UNITED STATES PATENT AND TRADEMARK OFFICE

APPLICATION NO.	FILING DATE	FIRST NAMED INVENTOR	ATTORNEY DOCKET NO.	CONFIRMATION NO.
10/010,246	12/06/2001	Robert Sixto JR.	SYN-064C	5866
27316 7590 10/19/2007 MAYBACK & HOFFMAN, P.A. 5722 S. FLAMINGO ROAD #232 FORT LAUDERDALE, FL 33330			EXAMINER EREZO, DARWIN P	
			ART UNIT 3773	PAPER NUMBER
			MAIL DATE 10/19/2007	DELIVERY MODE PAPER

Office Action Summary

DETAILED ACTION

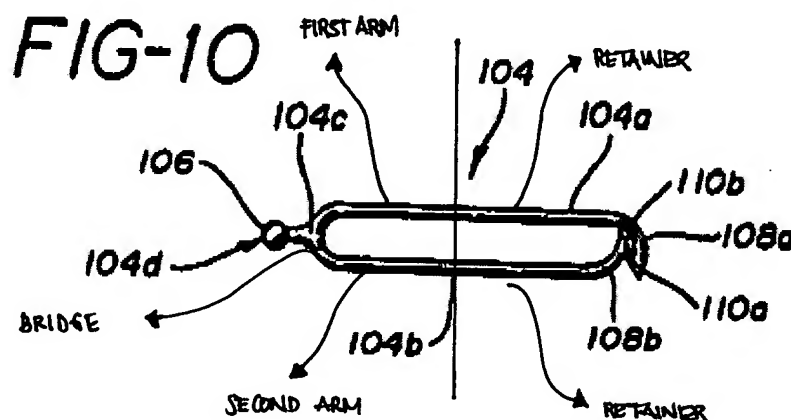
2. Claims 1-4, 7, 17, 18, 21-25, 28 and 32 are rejected under 35 U.S.C. 102(b) as being anticipated by US 5,222,961 to Nakao et al.

Nakao discloses a surgical clip, as shown in the attached Fig. 10 below, which comprises a first arm; a second arm; and a bridge connecting said first and second arms to form a substantially U-shaped structure. The arms also include a retainer portion attached thereto for penetrating through the tissue (Fig. 4). The length of the retainer, as shown below, is at least 3.14 times the distance between the arms when the arms are substantially parallel. The retainer is also capable of being deformed (change in shape) since the clip is taught as being made of a flexible material (col. 9, lines 41-44). Nakao also discloses the retainer having a tip portion that has a thickness smaller

than the thickness of the arm; wherein the retainer is a pair of deformable retainers having tip portions; and wherein a clip applier is provided that is capable holding a plurality of clips (Fig. 23A).
